**Co3265 – Pittsford-Brandon NH 019-3(494)**

**ADDENDUM #4**

Plan Sheets 30, 31, 32, 33, 36, 37, 226, 238, 256, 265, 270, 429, 432 & 433 have been revised.

FILE NAME: z02b198box\_112.dgn  
PROJECT LEADER: P. SHEDD  
DESIGNED BY: R. TRUDEAU  
PLOT DATE: 4/10/2026  
DRAWN BY: M. SMITH  
CHECKED BY: S. BEAUMONT  
TYPICAL EARTHWORK SECTIONS SHEET 2 BR 112 SHEET 265 OF 529

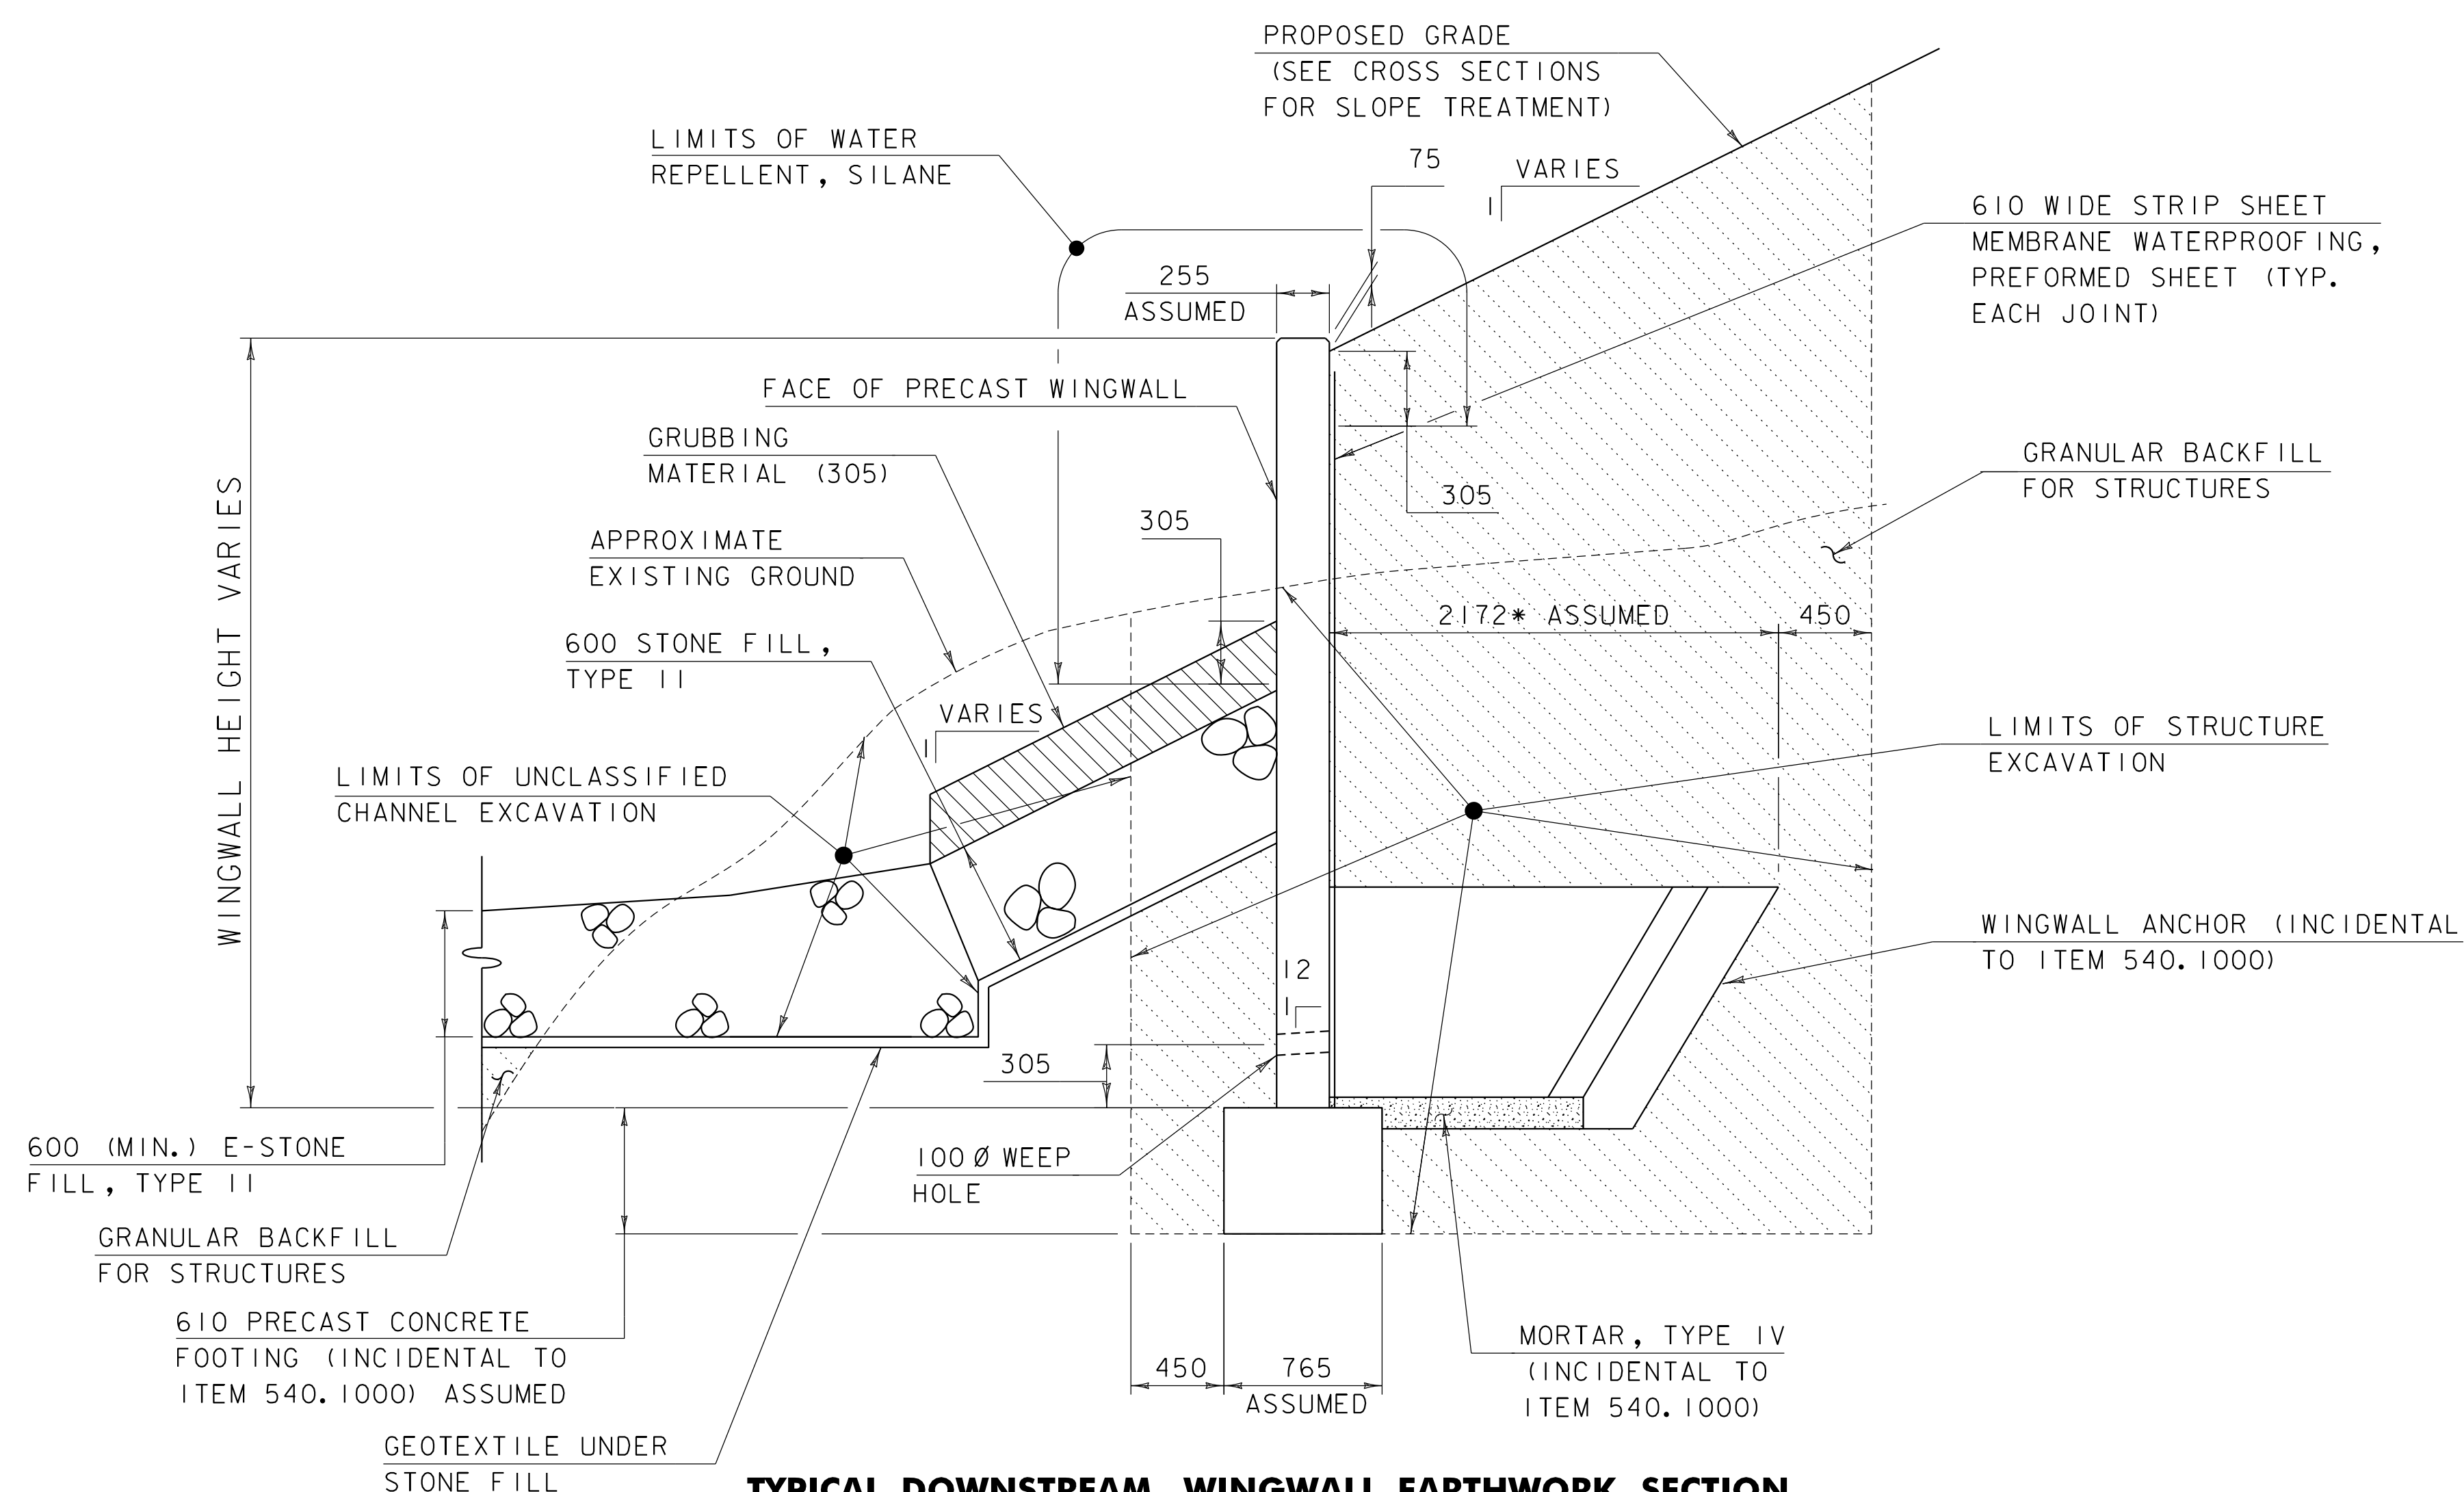
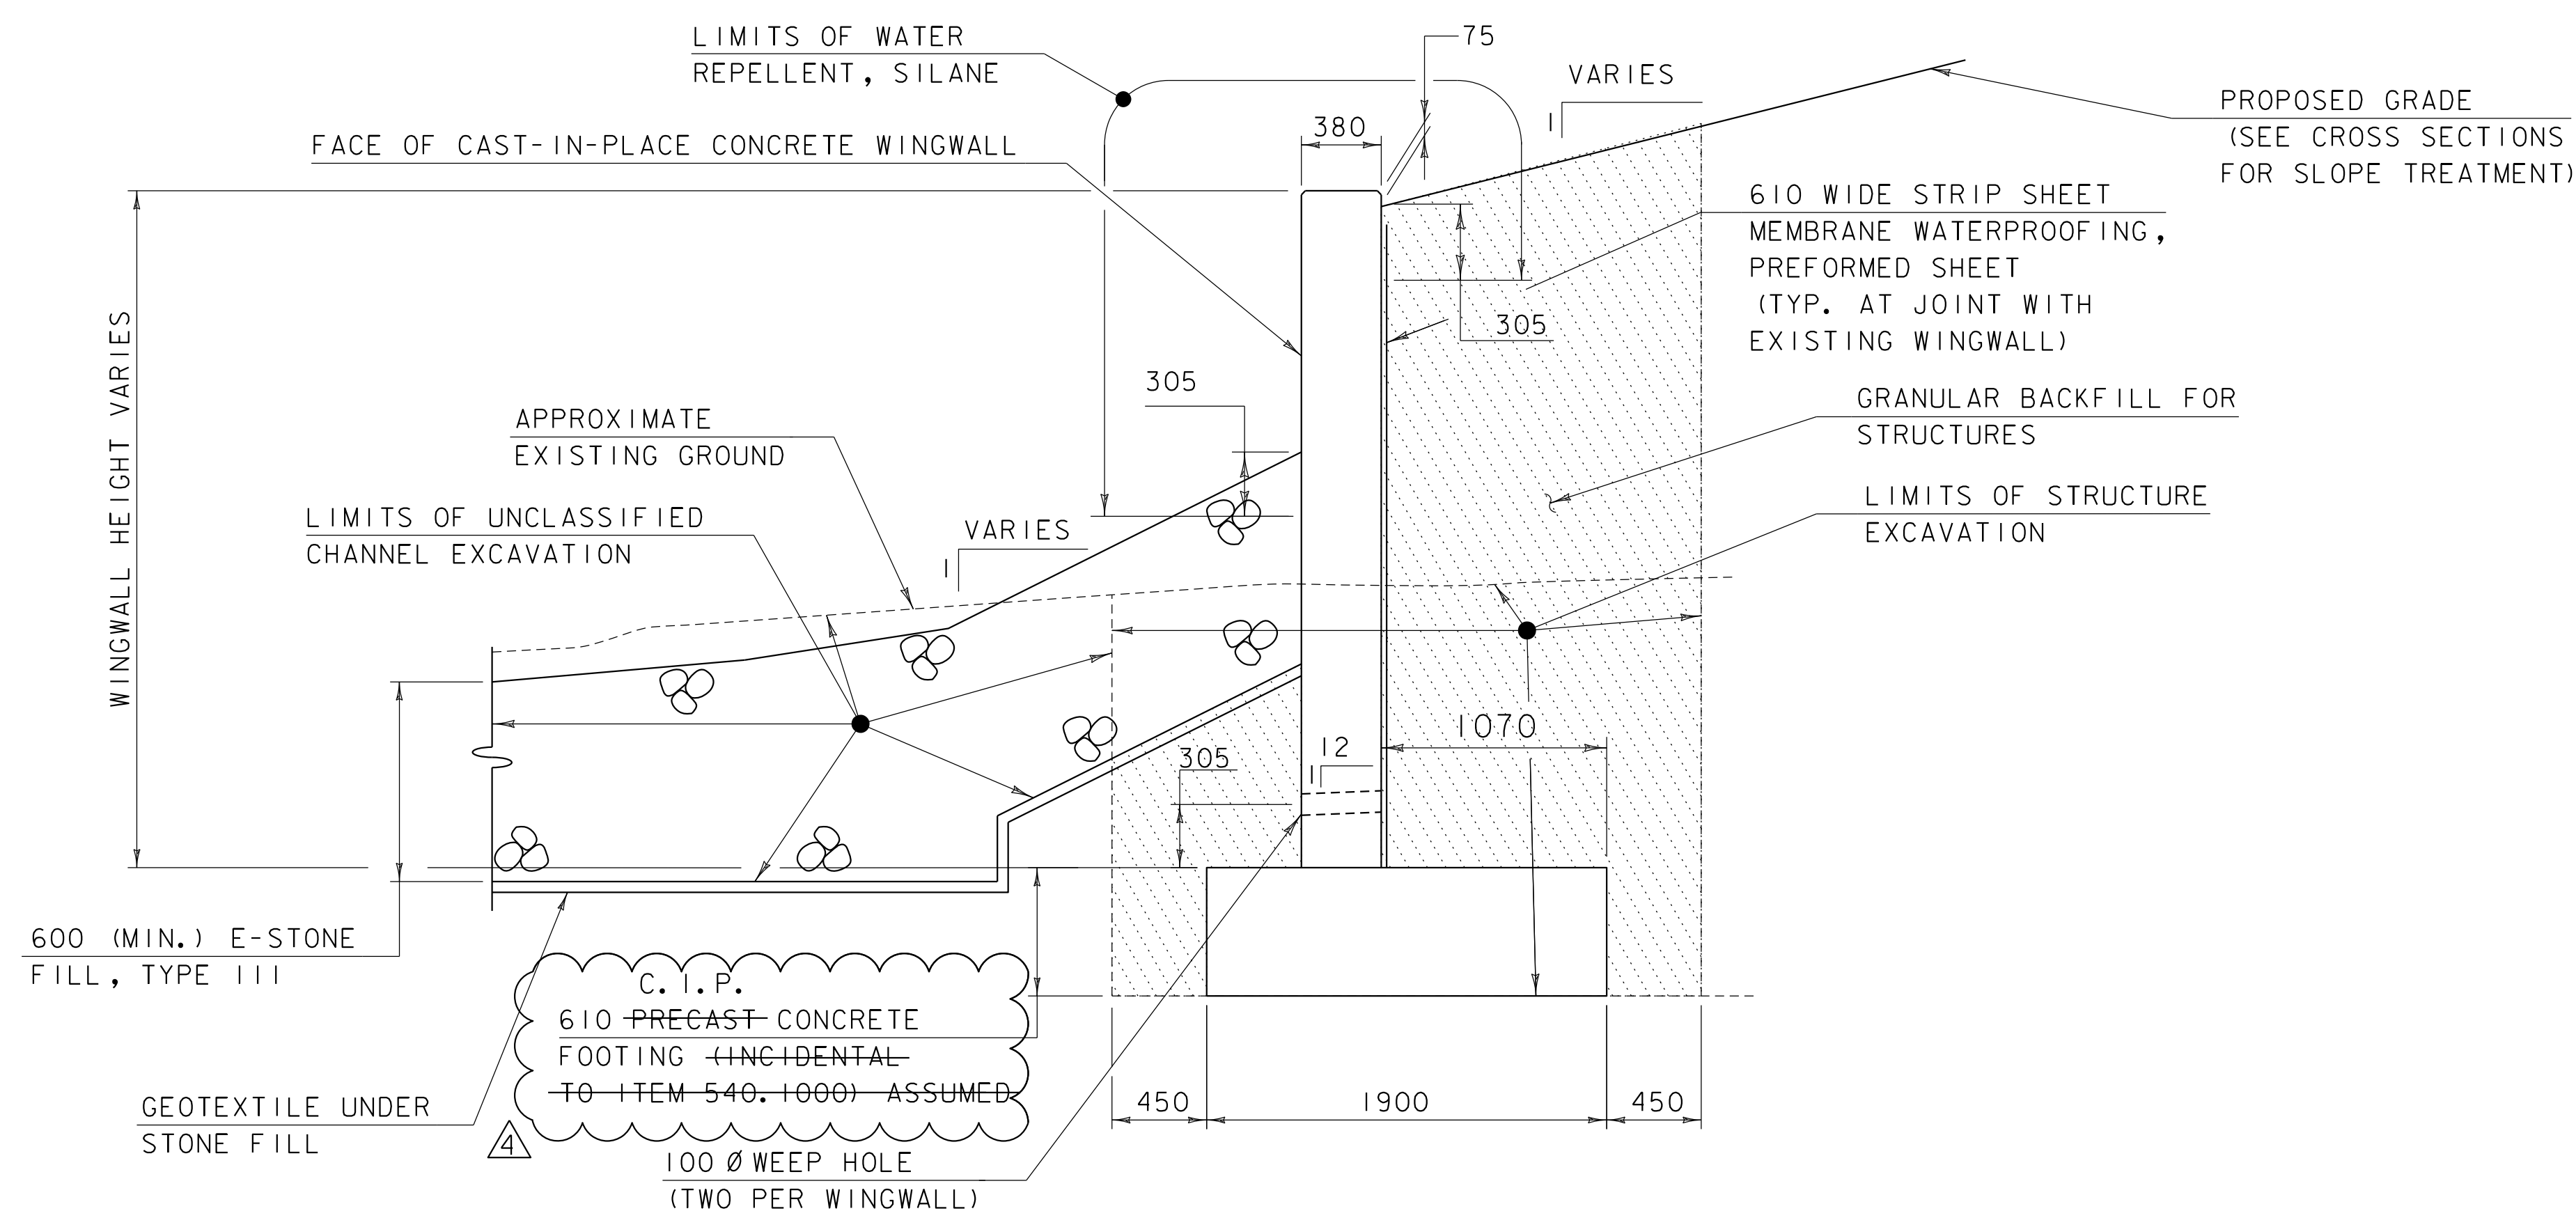
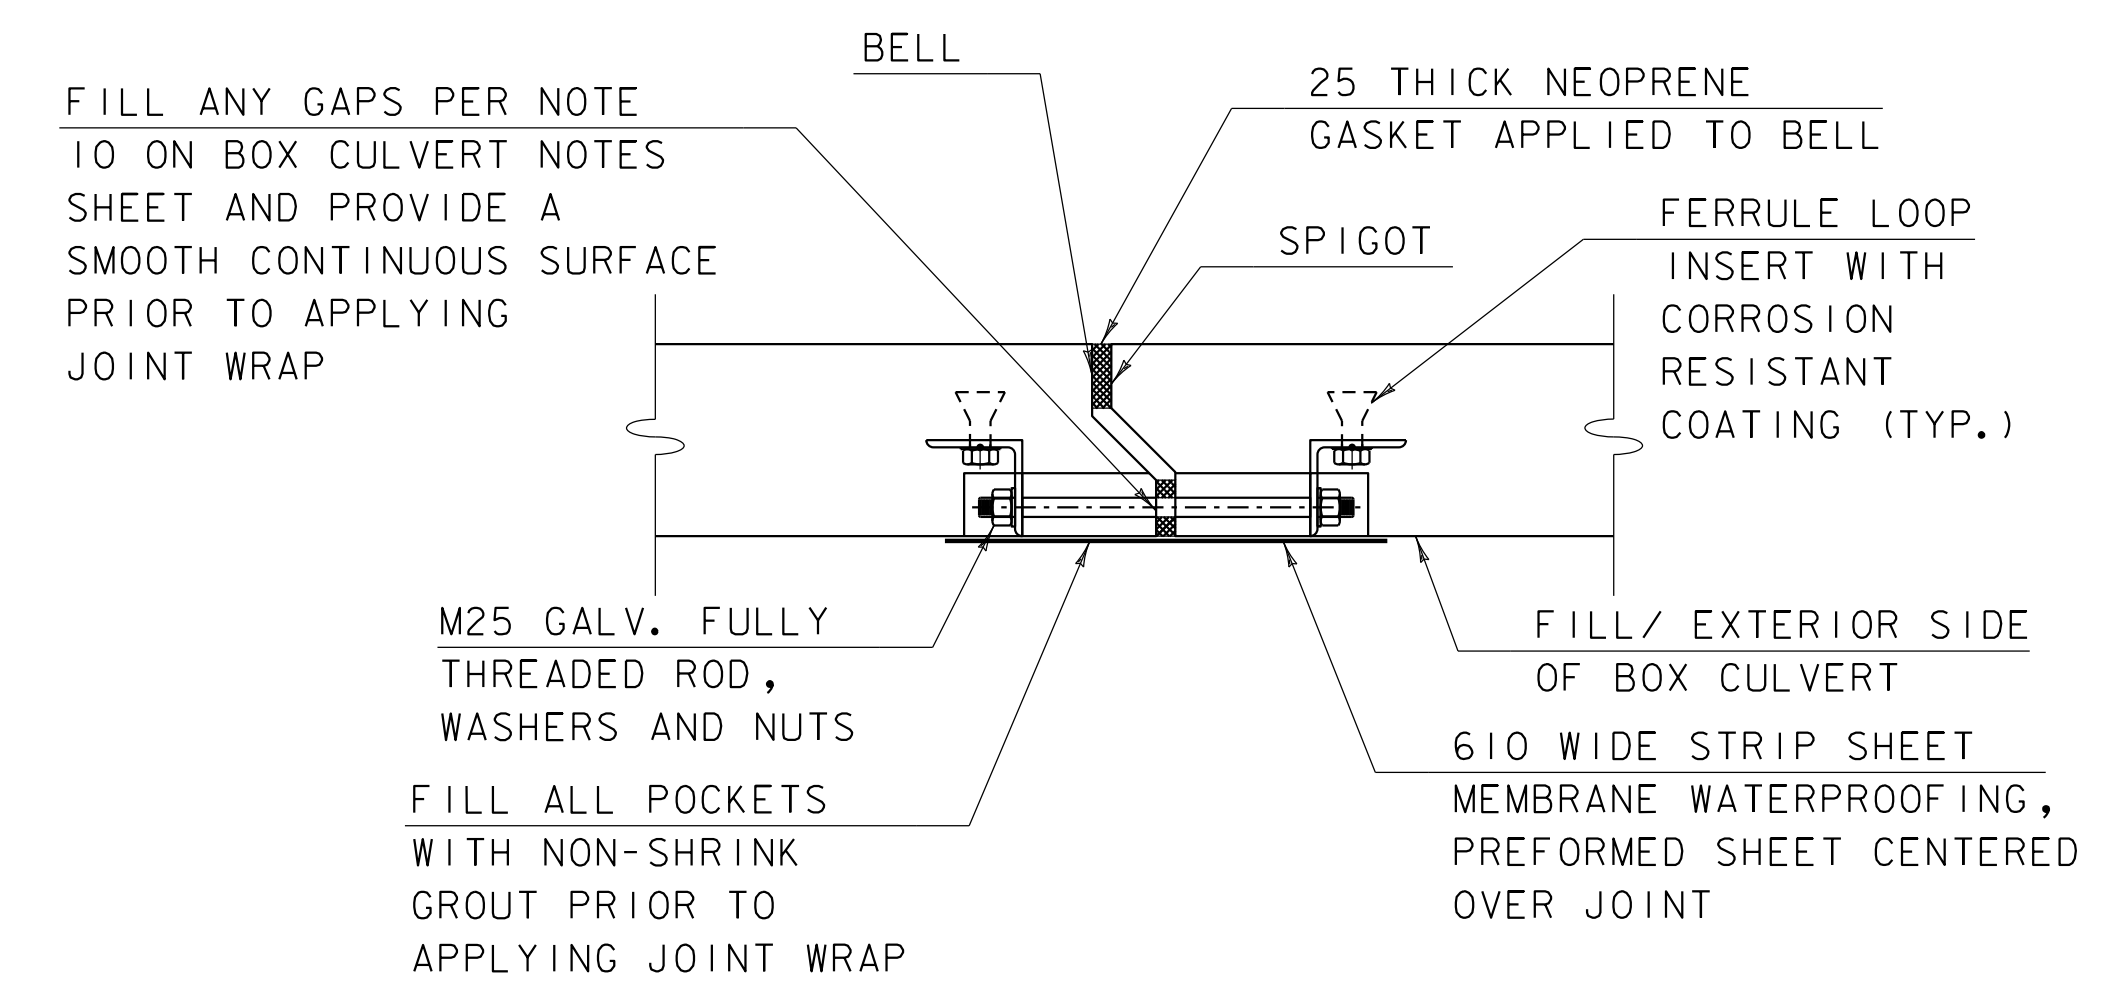
ADDENDUM	REVISION	DATE	DESCRIPTION	BY
△4	1	4-10-26	BR#112 UPSTREAM WINGWALL EXTENSION REVISIONS	SRB

3. SEE PRECAST CONCRETE BRIDGE SYSTEM NOTES ON BOX CULVERT NOTES SHEET FOR ADDITIONAL INFORMATION.
4. CONCRETE FOR THE UPSTREAM CAST-IN-PLACE CONCRETE WINGWALL EXTENSIONS SHALL BE PAID FOR UNDER ITEM 541.2200, "CONCRETE, CLASS B".
